PETITION NUMBER: V25-11

V25-11
13175 Hopewell Road

COMMUNITY DEVELOPMENT STAFF ANALYSIS

Re: Crescent Ridge Subdivision Variance Application

Exhibit A (Crescent Ridge Variance Site Plan)

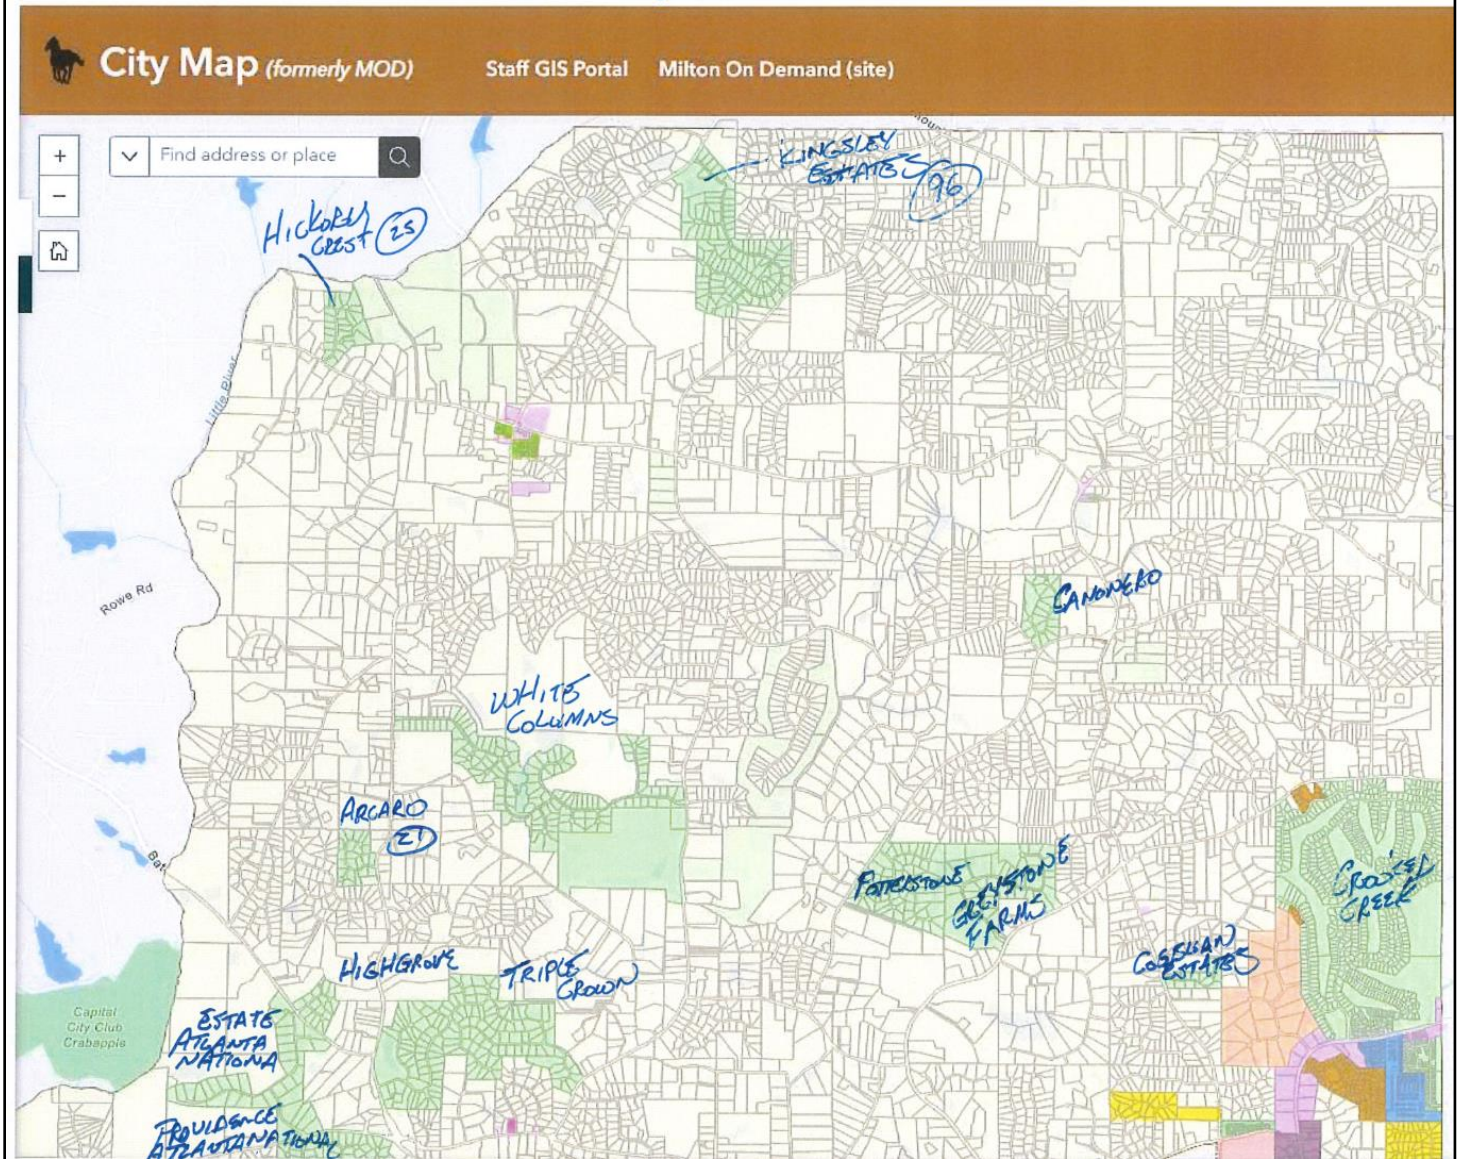
The proposed Crescent Ridge Subdivision has a depth of 961 feet and a width of 402 feet as shown on the variance site plan in **Exhibit A**. Statewaters are located along the east side of the proposed subdivision in close proximity to the three (3) cul-de-sac lots seeking lot width variances. The subject property was rezoned from AG-1 (Agricultural) to R-3 (Single-Family Dwelling) by the Mayor & City Council on July 15, 2013. The Land Disturbance Permit was issued by the Community Development Department on December 2, 2022.

- DRB recommends approval of the variance requests. The Board acknowledged the three (3) lots seeking lot width variances are all cul-de-sac lots that are impacted from statewaters located along the east side of the Crescent Ridge Subdivision. The Board acknowledged that the variance requests would move the front setback for all lots closer to the internal subdivision street, and move the rear setback for all lots farther away from the exterior bordering property owners. The Board also acknowledged the benefit of the pool setback being increased for all exterior bordering property owners.

- Per the Crescent Ridge Subdivision variance site plan from Brumbelow-Reese and Associates, Inc received on March 14, 2025 by the Community Development Department.
- The 35 feet rear yard (setback) shall increase to 50 feet for all eleven (11) lots.
- The 10 feet pool, pool equipment and pool decking setback shall increase to 20 feet for all eleven (11) lots.

Exhibit A (Crescent Ridge Variance Site Plan - Zoomed))

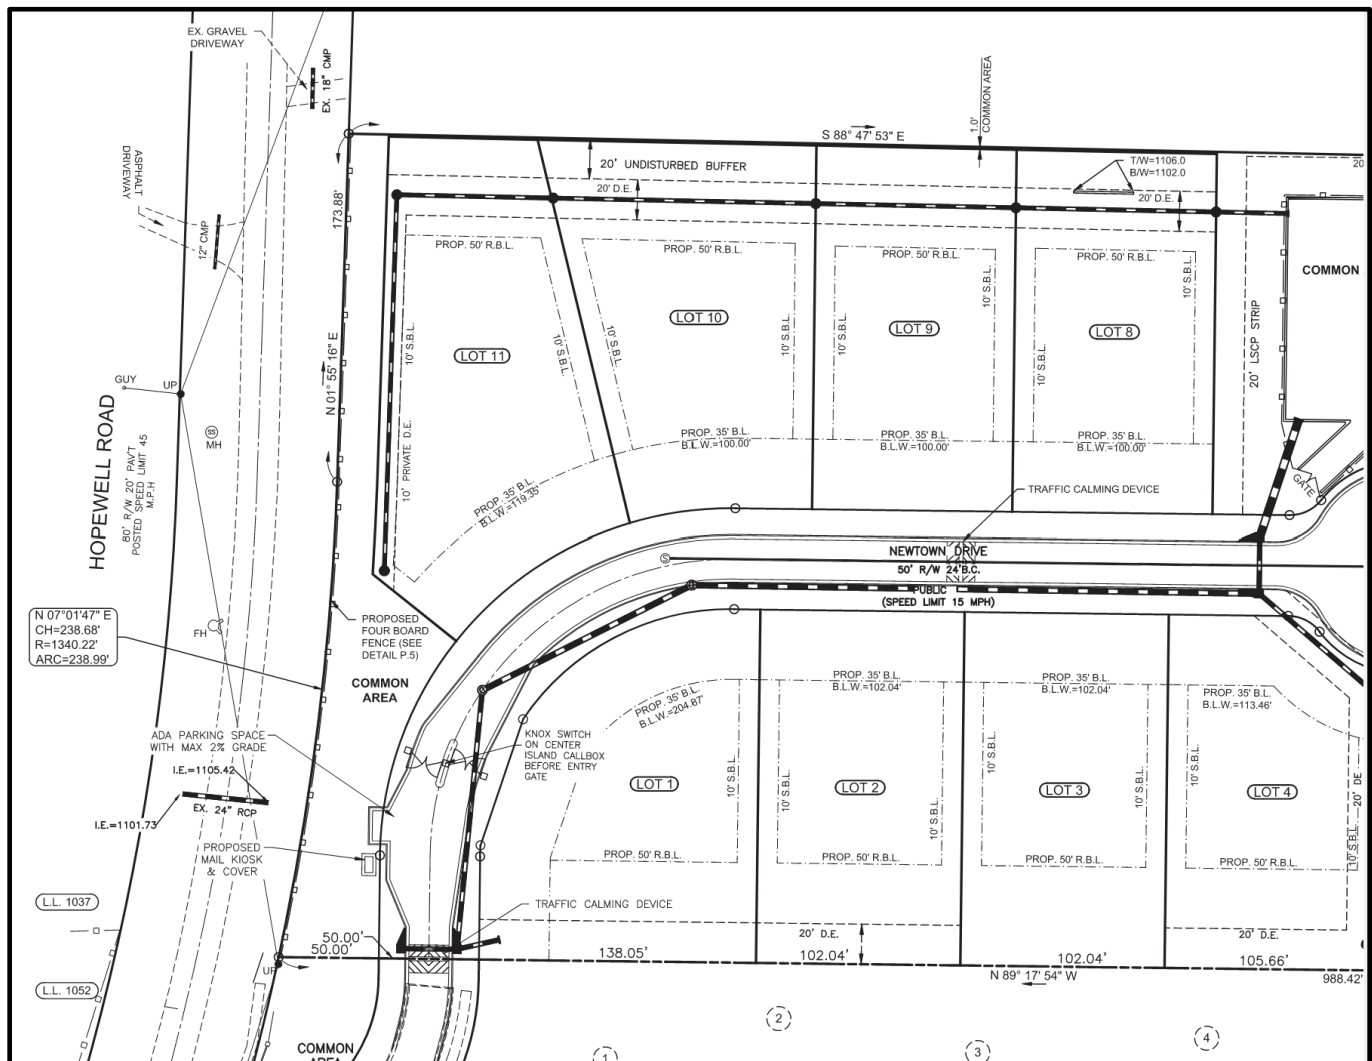
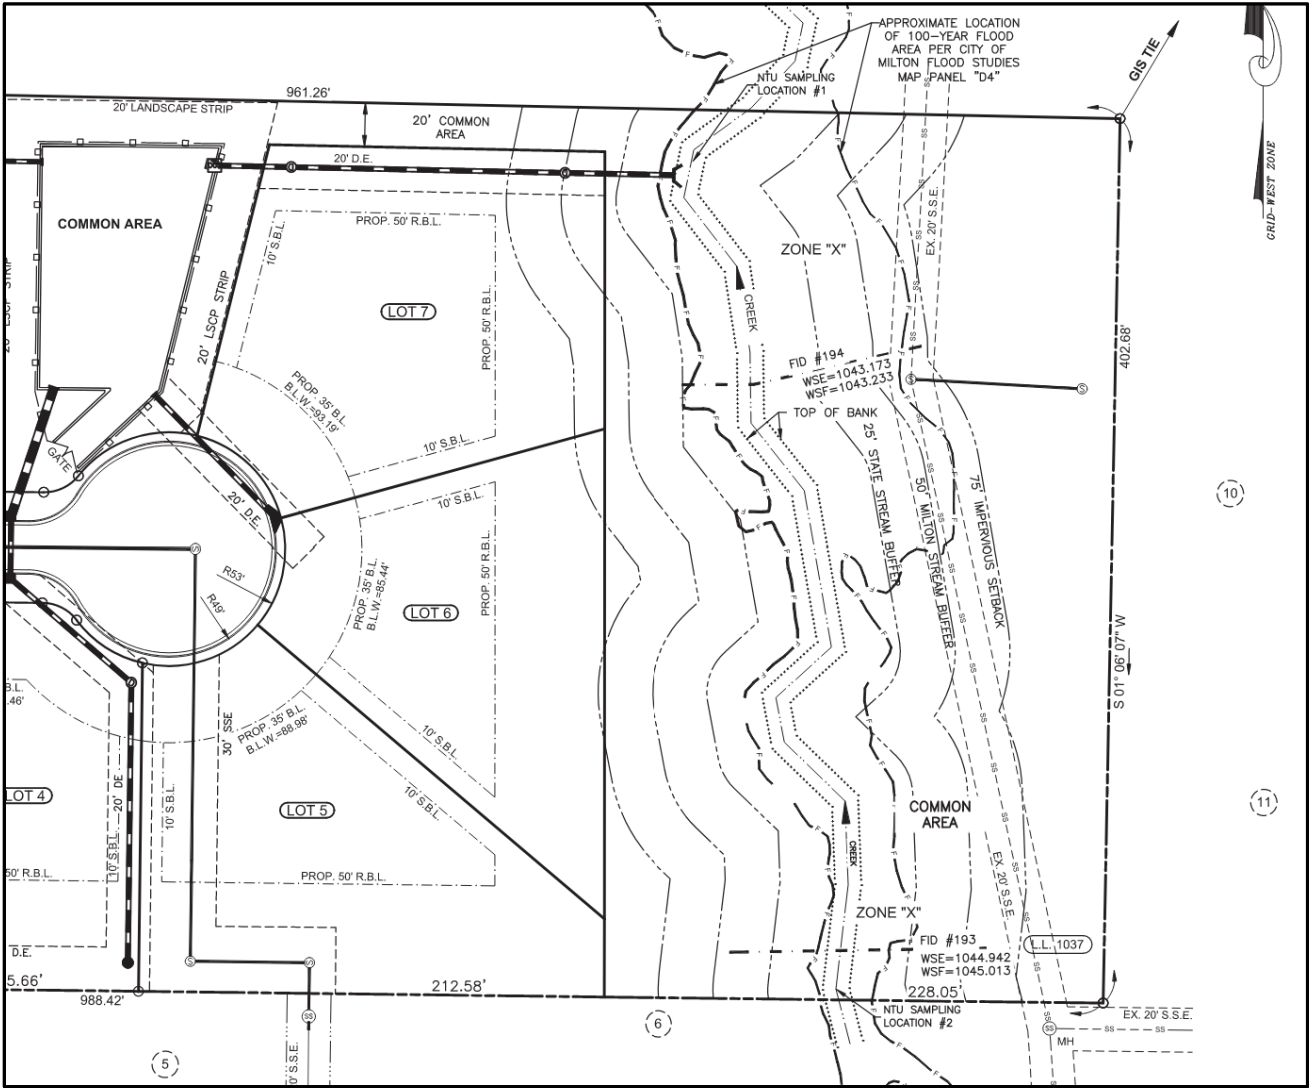
The applicant is also proposing the following setback increases as shown in **Exhibit B**.

- **Increase** the 35 feet rear yard (setback) to 50 feet for all eleven (11) lots.
- **Increase** the rear 10 feet pool, pool equipment and pool decking setback to 20 feet for all eleven (11) lots.
